<b><u>Application Ref</u></b>	<b><u>NP/16/0679/FUL</u></b>		
<b>Case Officer</b>	Kate Attrill		
<b>Applicant</b>	Bluestone National Park Resorts Ltd		
<b>Agent</b>	Mr L Page, Asbri Planning Ltd		
<b>Proposal</b>	Engineering works to facilitate the land train route from main resort centre, due north, to link with newly refurbished & extended car park to serve the Blackpool Mill proposal.		
<b>Site Location</b>	Blackpool Mill, Blackpool Bridge, Narberth, Pembrokeshire, SA67 8BL		
<b>Grid Ref</b>	SN06711386		
<b>Date Valid</b>	22-Feb-2017	<b>Target Date</b>	18-Apr-2017

Pembrokeshire Coast National Park Authority  
Development Management Committee – 10<sup>th</sup> May 2017

bluestone national park resort  
Scale 1:2500  
Date Oct 2016  
Drawn BY  
Design file  
Planning Issue - Site Plan

No title block  
Proposed Land Train for Resort and Blackpool Mill

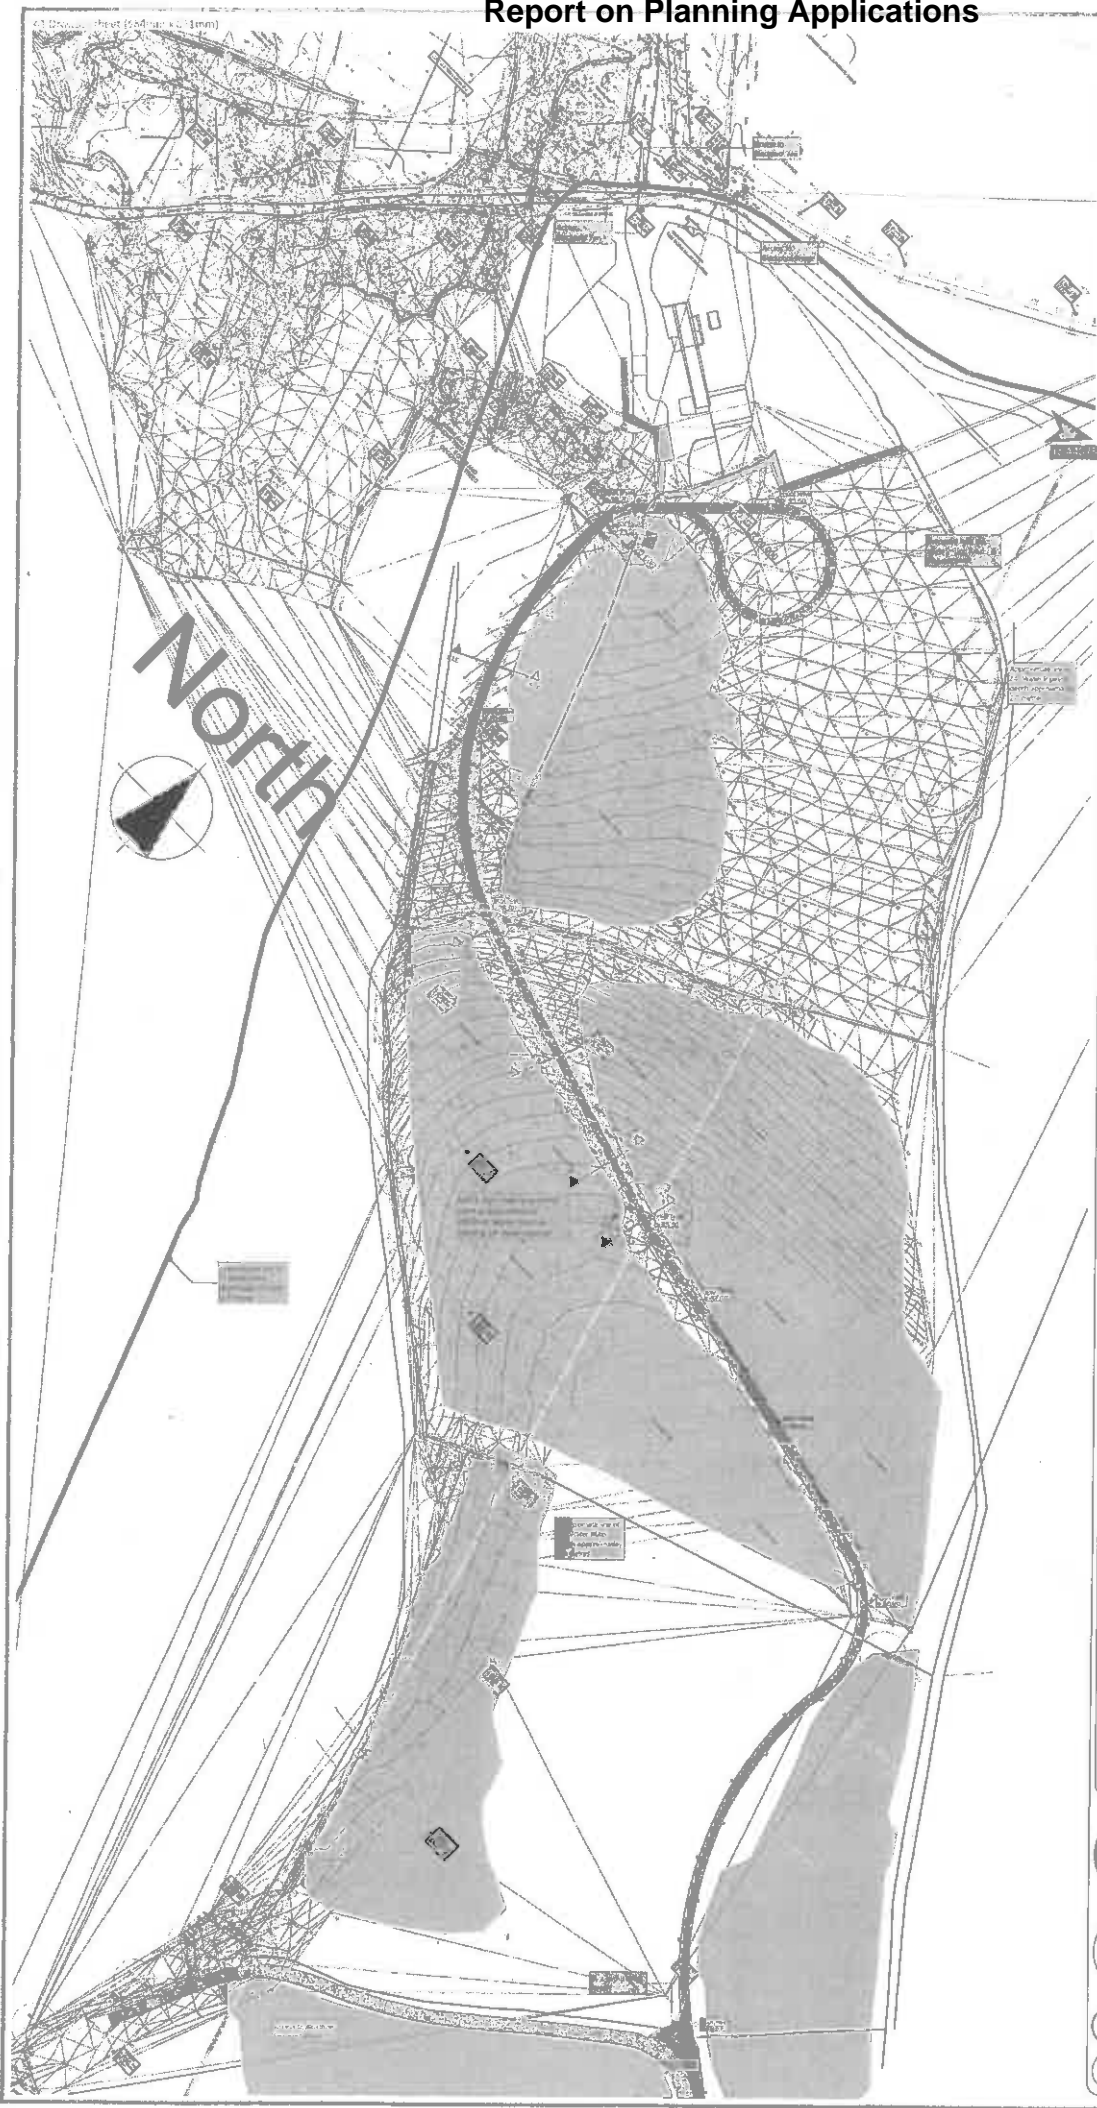
Lighting bollards are proposed every 18 metres of the route (in the lighting schedule) but every 17m on the submitted plans, and a covered cycle shed measuring 8.1 metres by 2.2 high by 2.1 wide is located adjacent to the proposed turning loop for the train.

The proposed route, measuring 4.6m in width and although will have an impact on the immediate landscape it will not be highly prominent in the landscape and the adjacent land will remain unaltered and is, therefore, not considered to negatively impact on the Special Qualities of the National Park.

The application has not included a survey of trees which will be impacted by the proposed foundations of the trackway. At 4.6 metres width with a depth of 1 metre, tree roots may be negatively impacted by the proposed engineering works, for which no assessment has been made. A survey may illustrate that alternative engineered details are required and should thus be produced prior to determination to either establish that there will be no harm to the trees along the route or that an alternative engineering solution needs to be designed. Based on the potential harm to a number of mature trees along the route, the application cannot be supported and fails to comply with Local Development Plan Policies 8, 11 and 15.

2. Insufficient information has been submitted in respect of a survey of trees which will be impacted by the proposed foundations of the trackway. At 4.6 metres width with a depth of 1 metre, tree roots may be negatively impacted by the proposed engineering works, the Local Planning Authority are unable to properly assess the impact on the trees without this information. . A survey may illustrate that alternative engineered details are required and should thus be produced prior to determination. Based on the potential harm to a number of mature trees along the route, the application cannot be supported and fails to comply with Policies 8 (Special Qualities), 11 (Protection of biodiversity) and 15(Conservation of the Pembrokeshire Coast National Park) of the Pembrokeshire Coast National Park Local Development Plan (2010).
